Date: May 9, 2022

To: Mammoth Lakes Planning Commission (PEDC)

Regarding: **Villas III - Onsite Snow Storage Problem**

DATE	01/17/22
SCALE	AS SHOWN
DRAWN	GP
JOB NO.	240.12
DWG	TTM5
SHEET	5 OF 6

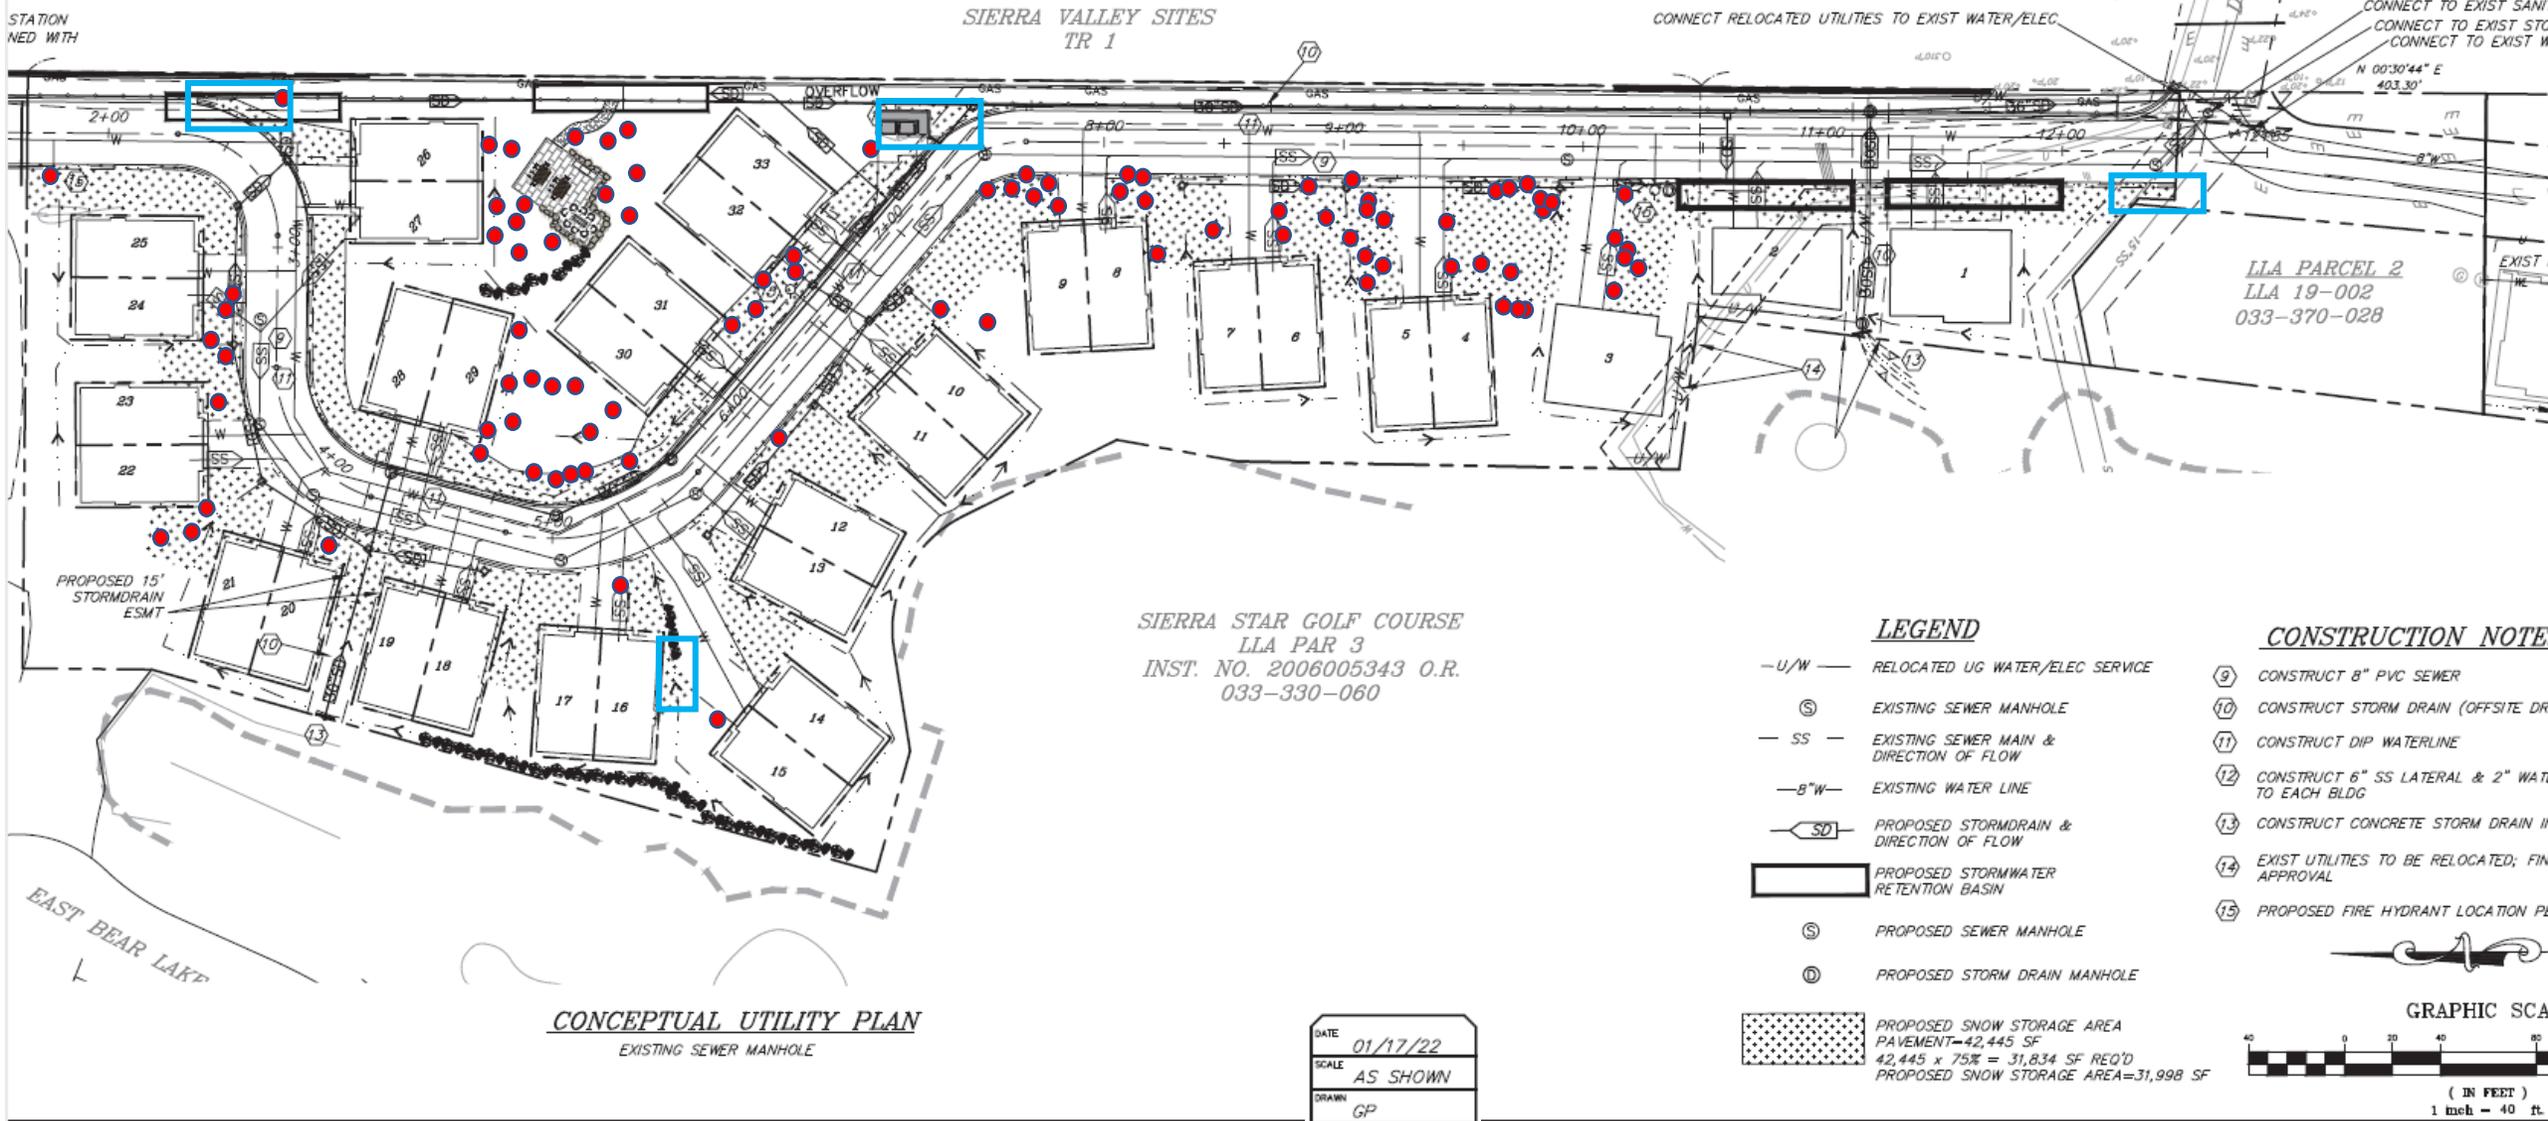
The Applicant's analysis fails to consider the 82 existing trees located in the middle of their planned snow storage area (see Attached). Trees are in the middle of at least 1/3 of the planned snow storage area. These areas with tree "obstructions" are not readily accessible by snow moving equipment, and do not qualify as snow storage per the Town's ordinance.

Additionally, their analysis includes areas much smaller than 10'x10' in size that do not qualify.

$$\begin{aligned} \text{Actual Snow Storage Area Proposed: } & \mathbf{21,084 \text{ SF}} \\ & = 31,998 - (10,664 \text{ for Trees}) - (250 \text{ for not meeting minimum size}) \end{aligned}$$

Additional onsite snow storage needed for compliance with Municipal Code: 10,914 SF

Existing Trees (red • dots) that will remain onsite (as shown on TTM 3 & 4). These areas do not qualify.

Areas not meeting the 10'x10' minimum area (blue box) also do not qualify.

thoroughly checked. Please require this project to meet the legal requirements for snow storage. **Their own documents show that almost 11,000 additional square feet of snow storage is needed and this significant miscalculation must be addressed.**
